MARIN GENERAL HOSPITAL REPLACEMENT BUILDING PROJECT

Response to Comments /
Final Environmental Impact Report
State Clearinghouse #2011092057

Prepared for
Marin Healthcare District

March 2013

Figure 2-2
Hospital Replacement Building Cross-Section A-A'
(as shown in Figure 2-3)

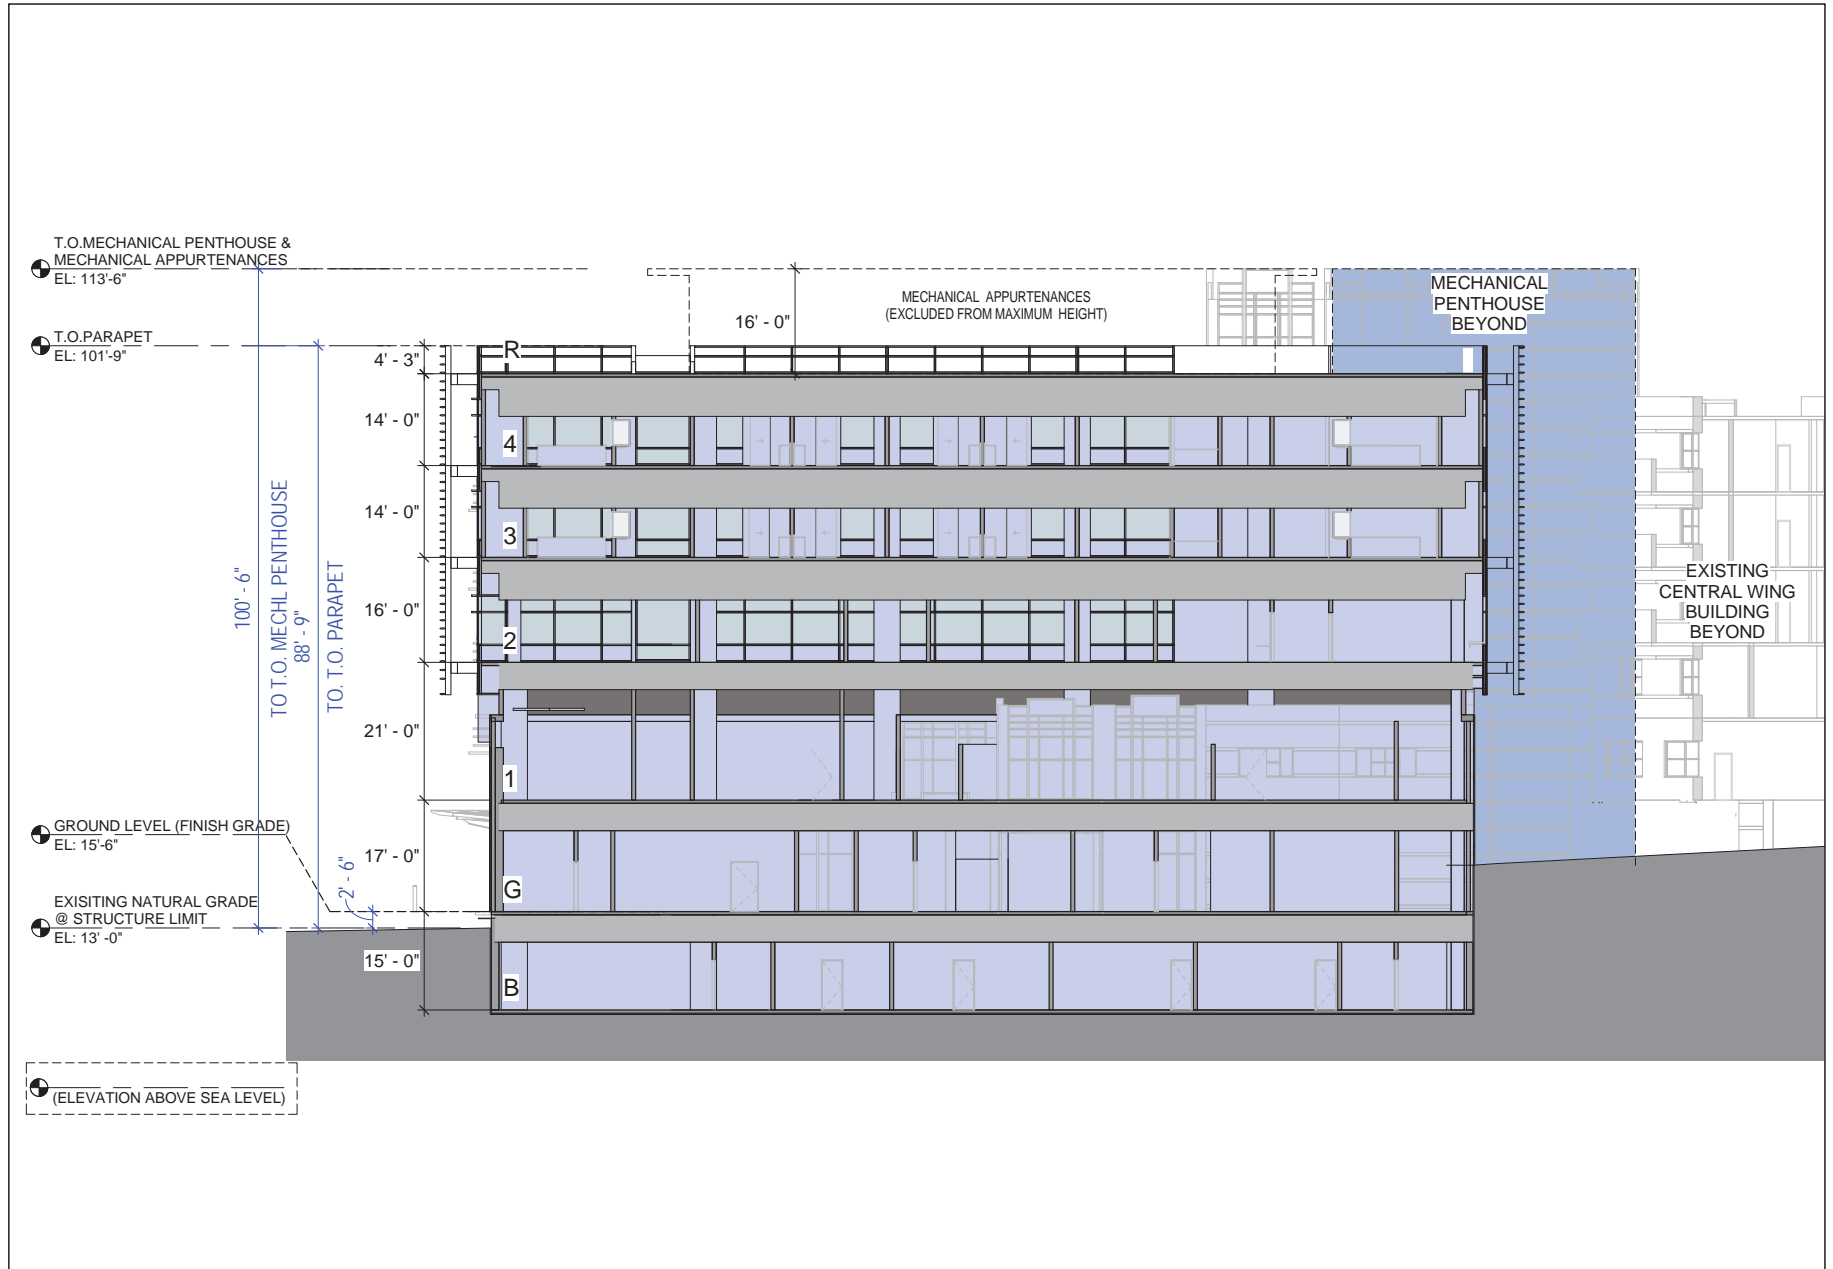
The HRB site slopes in two directions, making it somewhat complicated to portray and describe its height. More detailed measurements have been calculated, using as a worst case the northwest corner facing Bon Air Road where the building will be the tallest (see **Figure 2-2**). The HRB as proposed would rise 88 feet-9 inches from the existing natural grade to the top of the rooftop parapet, and 100 feet-six inches to the top of the mechanical penthouse. The planned finished ground surface adjacent to the building at this point will be 2 feet-six inches higher than the existing grade, to conceal the basement wall and provide for landscaping. In considering views of the building, it is relevant to note that the mechanical penthouses will be located on the east side of the roof closest to the Central Wing and East Wing behind the hospital. Therefore the added height of the penthouses should not be as visible from viewpoints to the west looking up at the building (e.g., from Bon Air Road or Corte Madera Creek).

The Draft EIR provides simulations of the HRB from several viewpoints (Draft EIR Figure 4.A-6 from Bon Air Bridge, Draft EIR Figures 4.A-7 and 4.A-8 from Corte Madera Creek South Pathway, Draft EIR Figure 4.A-10 from Creekside Marsh). The simulations were based on 88 feet-9 inches to parapet and 100 feet-six inches to penthouse (the same heights cited above). Thus the simulations accurately portray the building height for purposes of CEQA analysis and public review.

The HRB façade runs roughly parallel with Bon Air Road and 80 feet-six inches from the roadway property line at its closest point (see **Figure 2-3**). The building will be 125 feet-six inches from the property line to the south at its closest point.

Figure 2-9
Hillside Parking Structure Site Plan

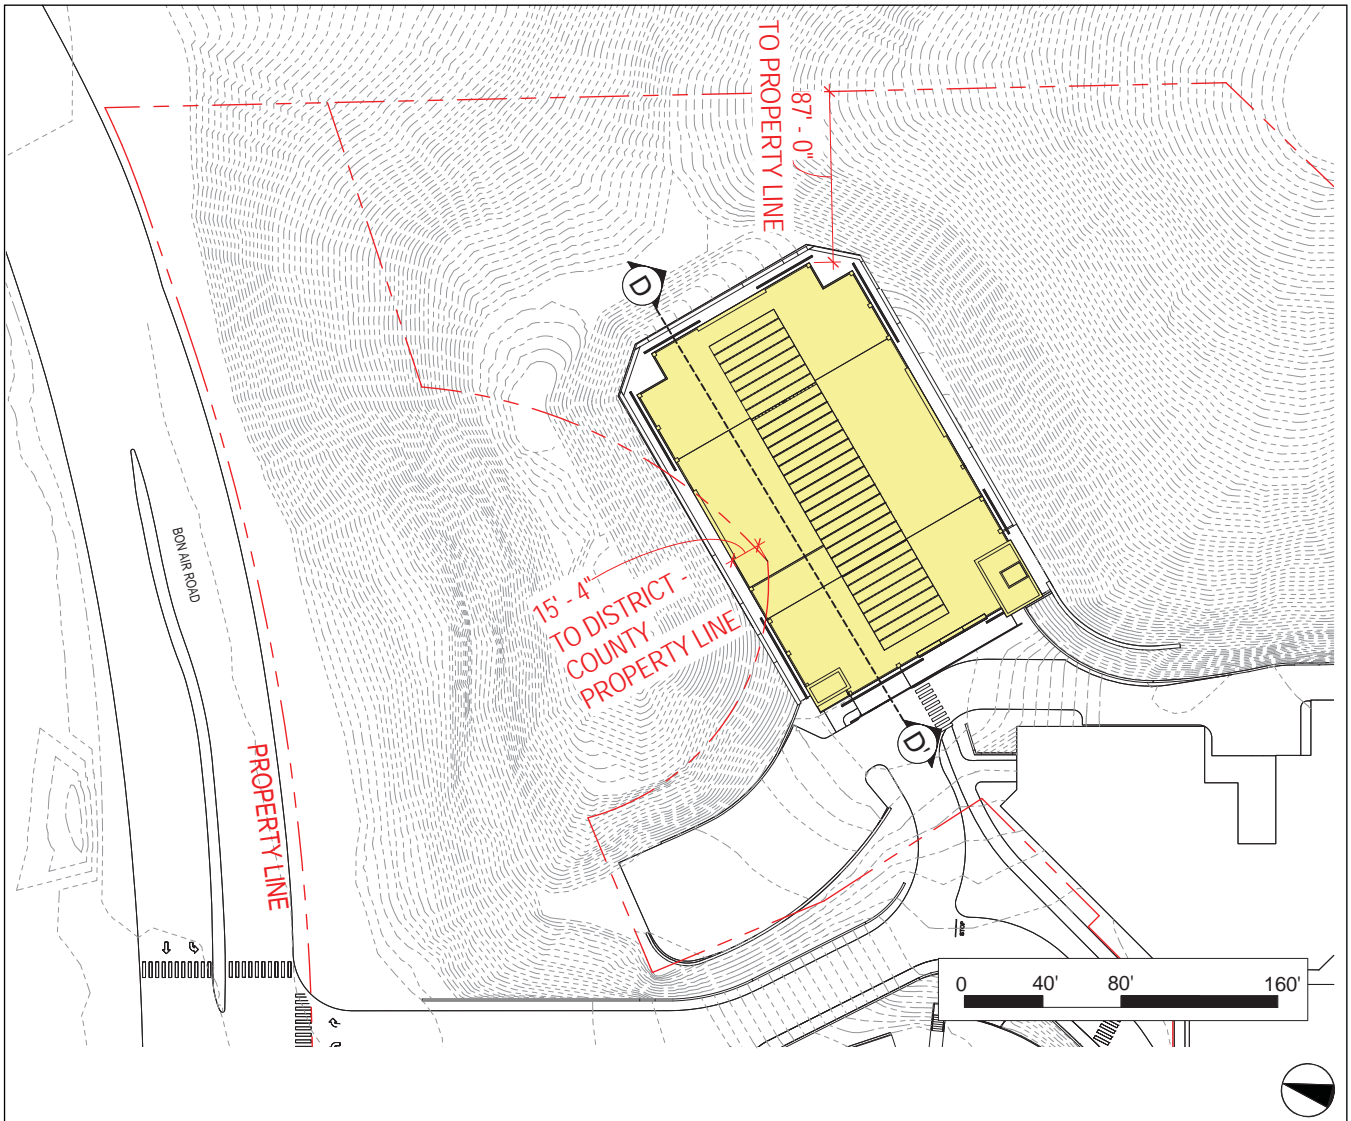
I am a property owner at Spyglass Hill, behind MGH. I attended the EIR meeting tonight and I've subsequently reviewed the MGH Replacement Building Project Draft. Figure 4.A-12 does not depict the hillside parking structure proposed on the hillside behind MGH. I've not noted it in any other of the figures either. This structure, if as verbally proposed, could be a significant detriment to the hillside residents both in terms of noise and pollution, in addition to local traffic and ultimately on our property value.

Figure 2-9 shows the location of the Hillside Parking Structure in relation to property lines. The parking structure site straddles the property line between the District’s hospital property and the parcel jointly owned by the District and the County. As discussed in the Draft EIR (initially at Chapter 1), the parties are considering possible arrangements such as a land swap or a ground lease to allow the District to use the jointly-owned parcel for the structure – which may include a lot line adjustment so the entire structure can sit on one parcel. The eastern corner of the structure would be 87 feet from the property line between the District-County parcel and the Via Hidalgo residential development at the top of the hill.

Starting on page 2-12 of this Final EIR, see the detailed updated description, section (Figure 2-8) and plan (Figure 2-9) that update and clarify the dimensions and setbacks of the Hillside Parking Structure in Chapter 2 (*Project Clarifications and Additional Information*). Section 2 also includes a series of photos and visual simulations of the Hillside Parking Structure, as viewed from the nearby hillside residential area to the site (Figures 2-11 through 2-15).

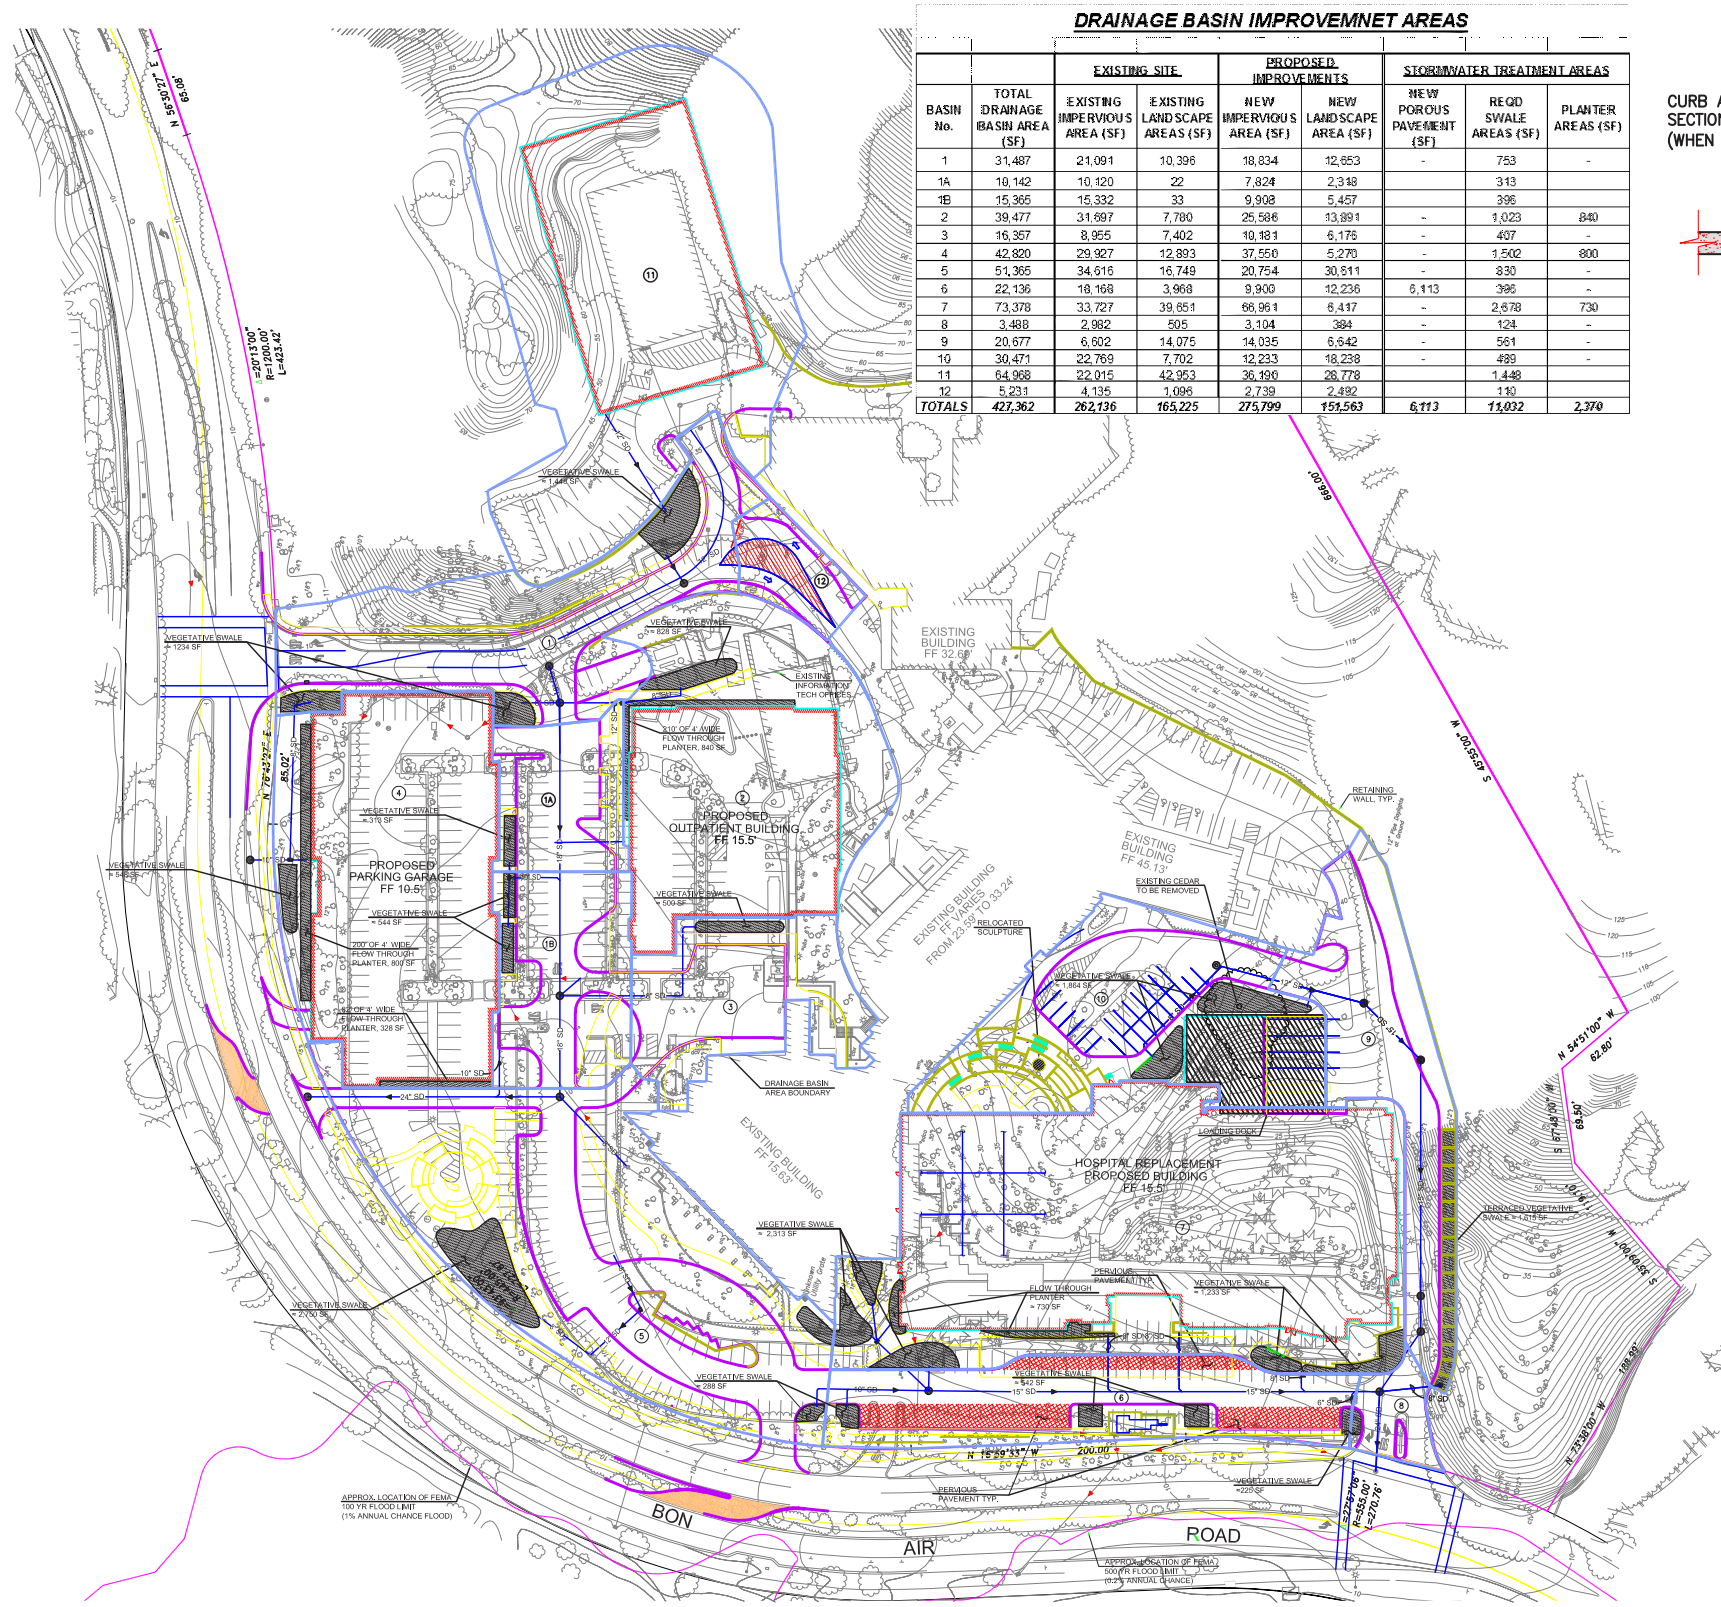
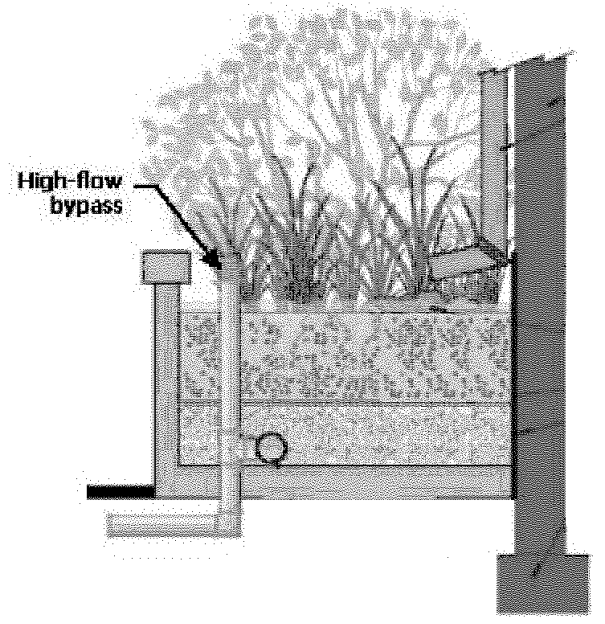
- g. Section 3.6.6, page 3-51, indicates a conceptual Stormwater Control Plan, and refers to Figure 3-17, though no figure 3-17 is provided in the document (figures 3-17a through 3-17f depict Phases of construction activity). Provide a conceptual stormwater plan.

- c. Page 3-52, of section 3.6.6, refers to a conceptual Stormwater Control Plan presented in Figure 3-17, though no figure 3-17 is provided in the document. Figures 3-17a through 3-17f depict phases of construction activity.

- 21) New Figure 3-18, Preliminary Stormwater Control Plan, is added following Draft EIR page 3-62, and is shown two pages from here, following Figure 3-14R.

D-13-g: New Figure 3-18, Preliminary Stormwater Control Plan is provided in Chapter 3 (Changes to the Draft EIR) in this Final EIR.

- I-10: See new Figure 3-18, Stormwater Control Plan, in Section 3 (Changes to the Draft EIR) in this document. All features will be located on MGH property and thus maintained by the hospital. The District has elected to remove the bioswale element previously proposed in the ROW in response to County comments concerning private development proposed in the public roadway median, not due to the merits or lack thereof of the water quality elements. The commenter provides no evidence that such long-term water quality elements would cause adverse impacts to water quality for the project. These features are retained on the project site, as shown in new Figure 3-18.

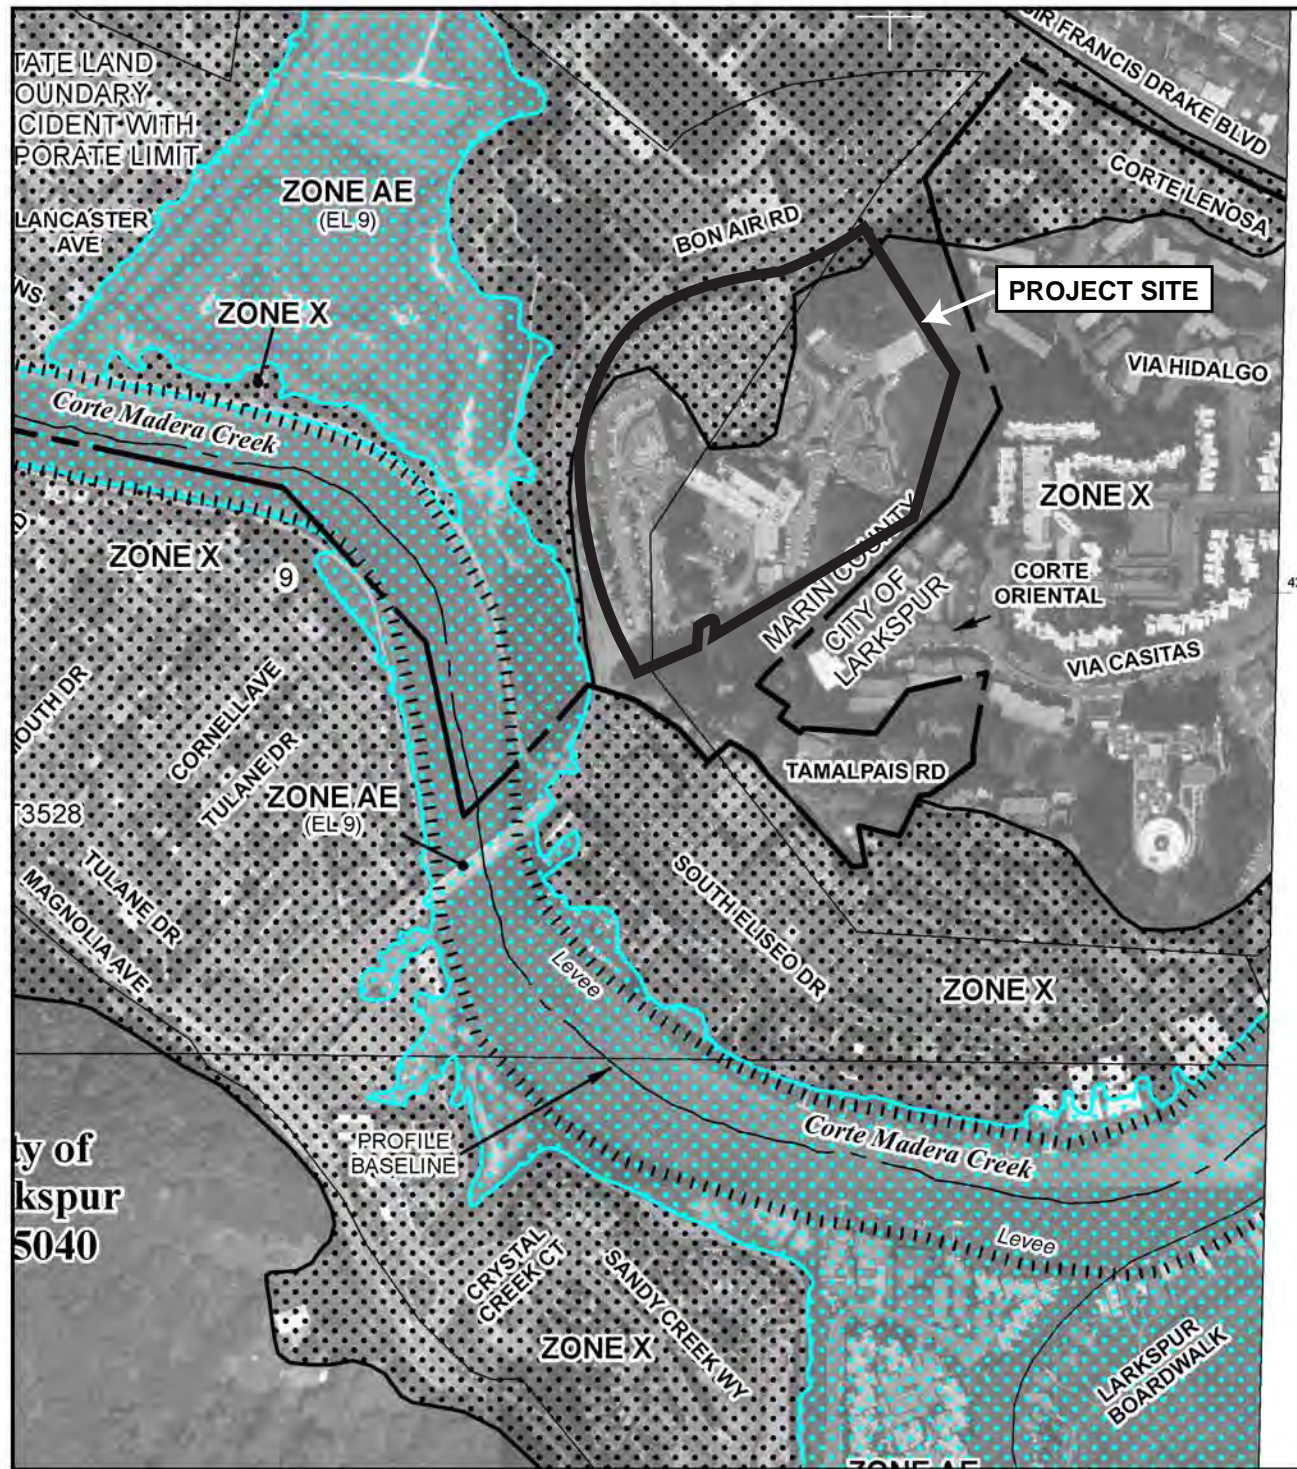
- d. Figure 4.N-2 Proposed Utility Lines depicts a bio-swale to be constructed in one of the road medians in the Bon Air Road right of way. Use of the public right-of-way for private development mitigations is usually not permitted. Revise this drawing, and project if necessary, to place all stormwater mitigation on site.

- a. Figure 4.N-2 is inaccurate and inconsistent with the rest of the document as it depicts a new bio-swale being constructed in the county right of way in an existing median. This is not discussed elsewhere in the document and is not on the applicant's private property.
- b. IMPACT UTIL-5 figures 4.N-3 through 4.N-6 are schematic and do not offer sufficient detail for evaluation of potential impacts of traffic control measures, construction nor and mitigations to reduce impacts to safety.

- 77) Figure 4.N-2, A Proposed Utility Lines, on Draft EIR page 4.N-4 is modified to remove proposed bioswales in the Bon Air Road median, as shown on the following page as Figure 4.N-2R.

D-18-d: Draft EIR Figure 4.N-2, Proposed Utility Lines, on Draft EIR page 4.N-4 is modified to remove proposed bioswales in the Bon Air Road median, as shown in Chapter 3 (Changes to the Draft EIR) in this Final EIR as Figure 4.N-2R.
